**CONTRACT CHANGE ORDER**No. 002Date 03/02/2022EDF # 20-040

Contract No. WWTP-2021-48 for the following public work: 2021 Wastewater Treatment Facility Upgrades Project between C.D. Smith Construction, Inc. and the City of La Crosse, dated April 8, 2021, is hereby changed in the following particulars, to-wit:

**CHANGE ORDER NO. 002**

CHANGE ORDER DATE OF ISSUANCE	<u>March 3, 2022</u>	COMMENCEMENT OF CONTRACT TIME	<u>May 3, 2021</u>
OWNER	<u>City of La Crosse</u>		
CONTRACTOR	<u>C.D. Smith Construction, Inc.</u>		
PROJECT	<u>2021 Wastewater Treatment Facility Upgrades</u>	EDF NO.	<u>20-040</u>
ENGINEER	<u>Donohue &amp; Associates, Inc.</u>	CONTRACT NO.	<u>13655/13735</u>

CITY OF LA CROSSE  
 2021 WASTEWATER TREATMENT  
 FACILITY UPGRADES  
 LA CROSSE WISCONSIN  
 EAST DIGESTER BUILDING  
 SECTION

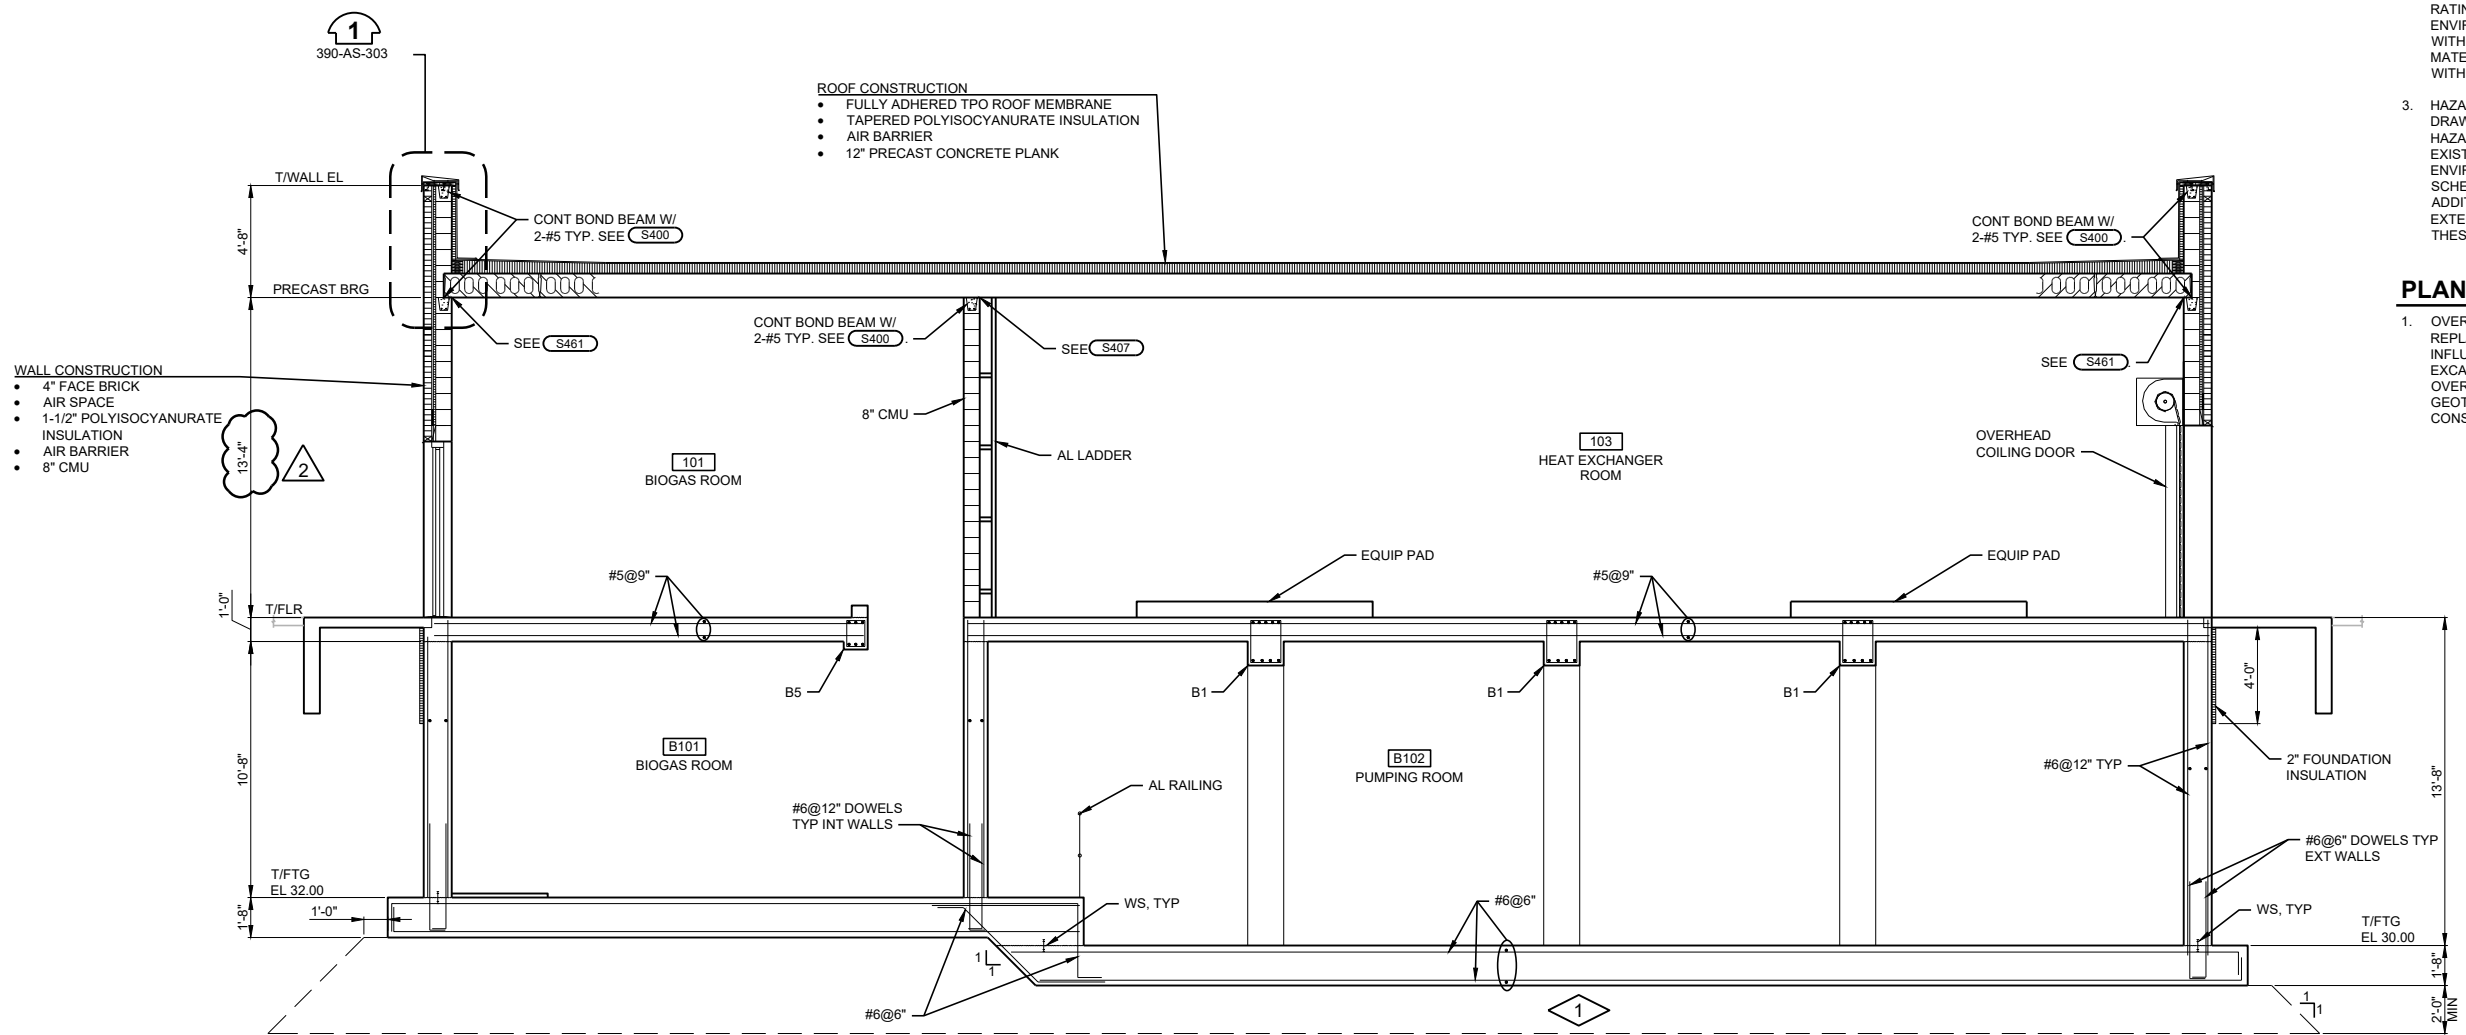
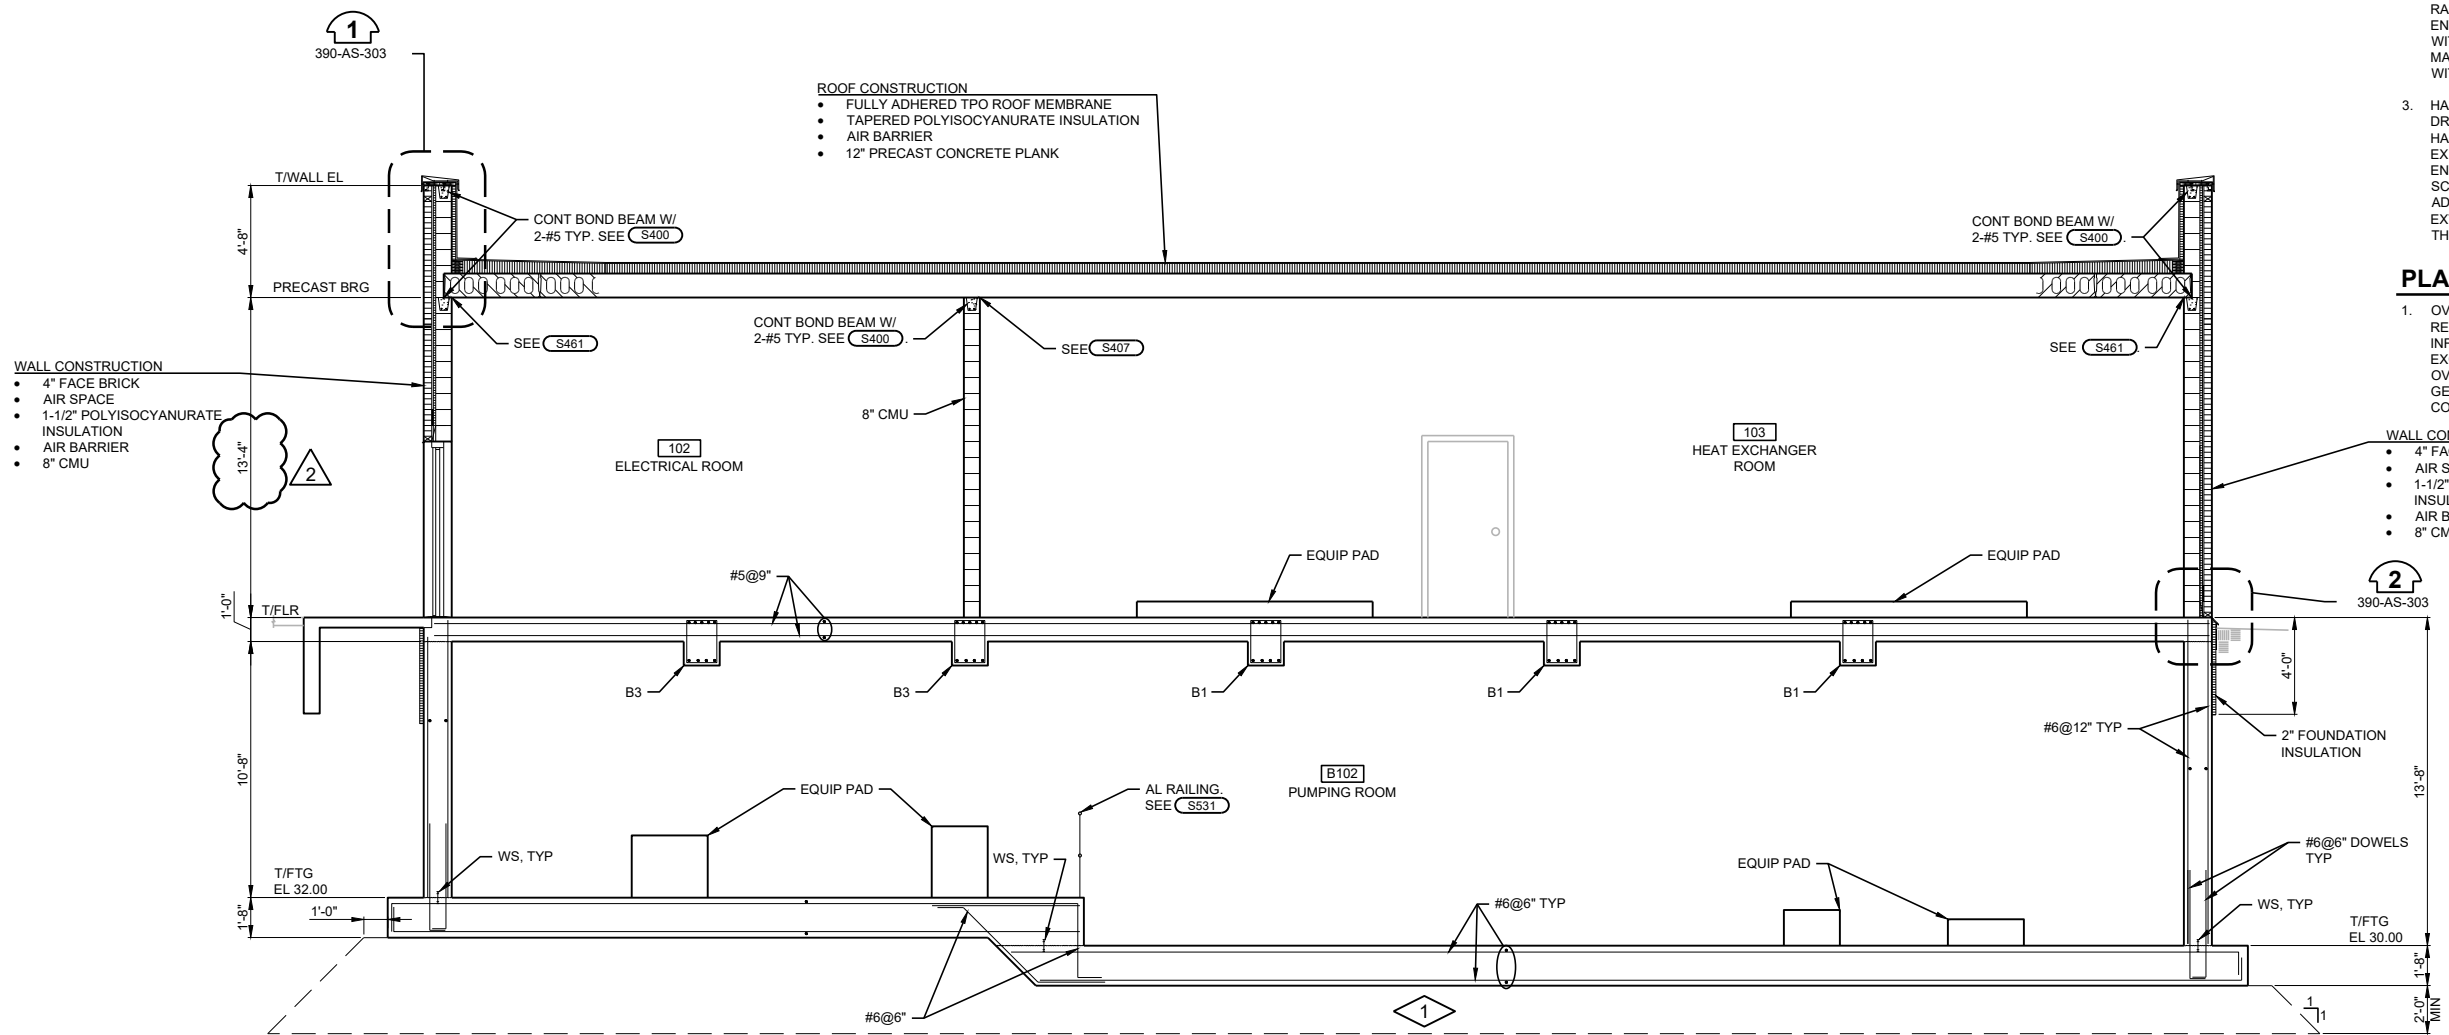
This Request for Proposal (RFP) is being prepared to increase the roof elevation of Structure 390. This 8" elevation increase will allow for installation of the vent/bleed valve on top of the 6" DS pipe per RFI 058. The DS piping in Structure 390 cannot be lowered due to other conflicts within the structure. See attached marked up drawings for additional details.
